A. EIS Submissions

SUBMISSION: GLADSTONE LNG PROJECT (SANTOS AND PETRONAS)

GLADSTONE LNG PROJECT

Yours faithfully

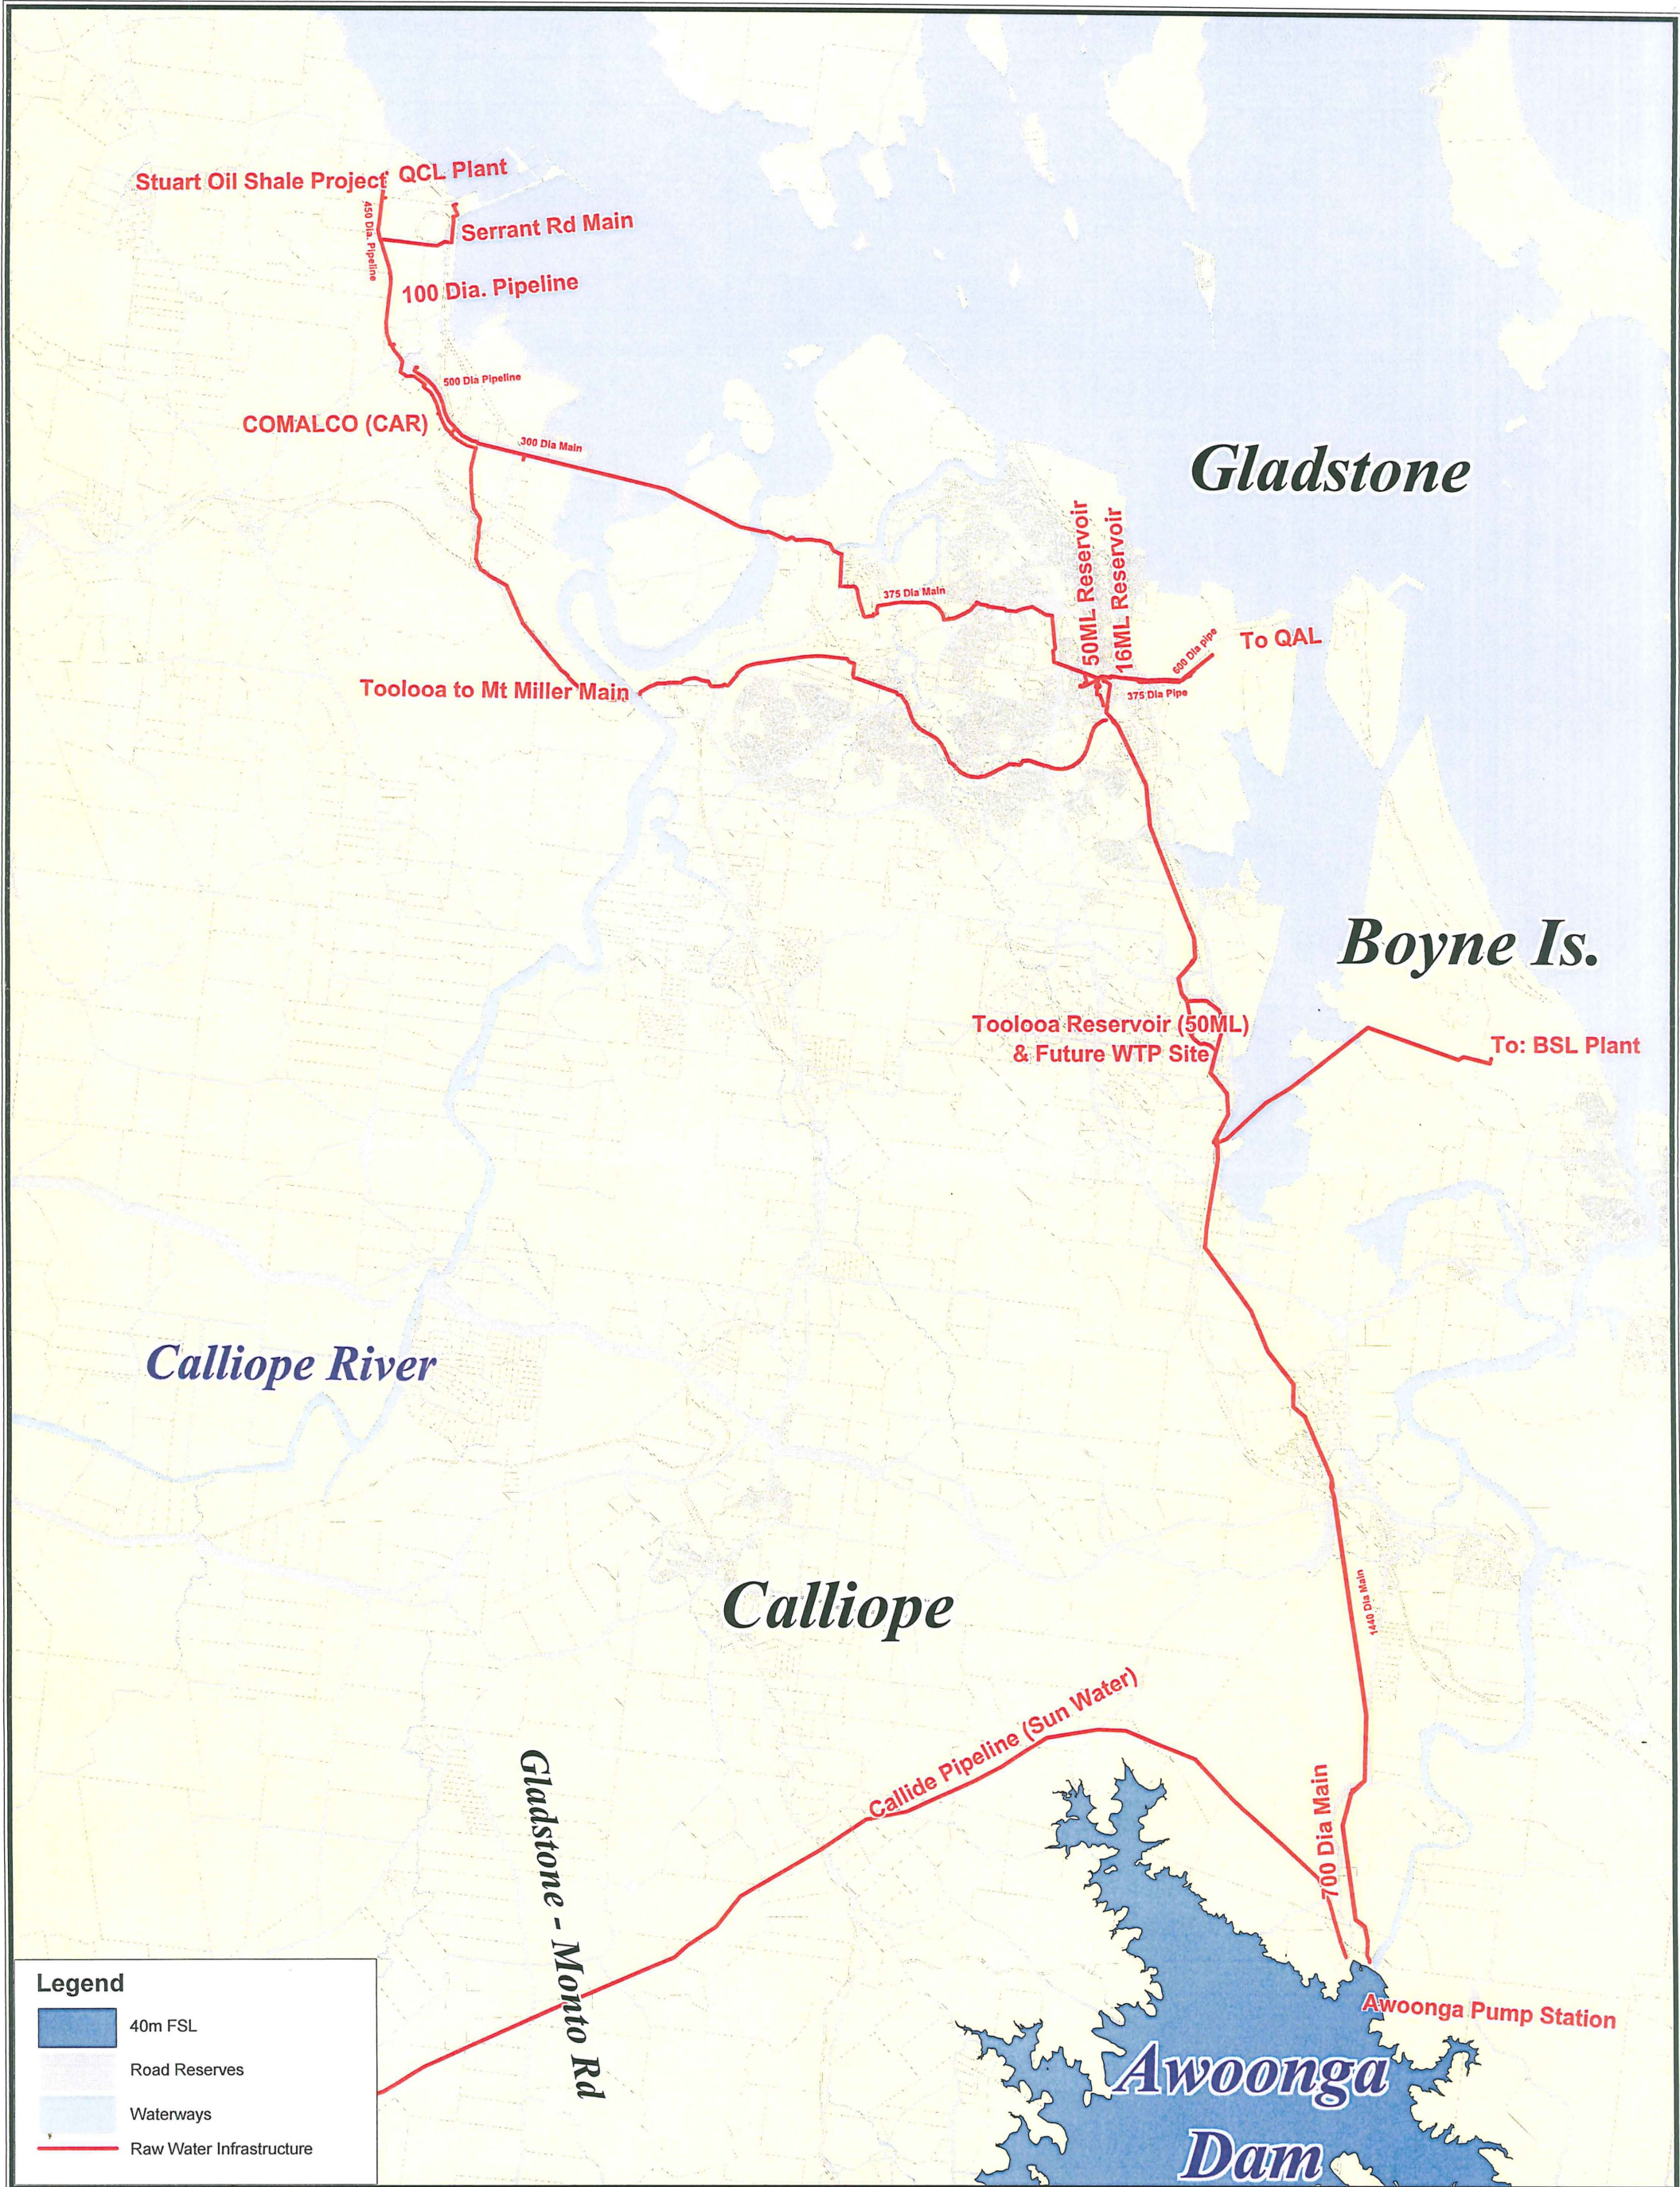
GAWB’s raw and potable water distribution network ends at Fisherman’s Landing area, only a short distance from the proposed GLNP pipeline crossing (refer to URS figure ES4, attached). GAWB’s raw and potable water networks have capacity to supply Curtis Island customers from this point.

Accordingly, it is submitted that there is merit in the Proponent (in consultation with GAWB) producing an analysis of the comparative environmental and economic impact should it meet its water supply requirements (both construction and operation) from GAWB's water supply network, as opposed to from a stand-alone desalination facility.
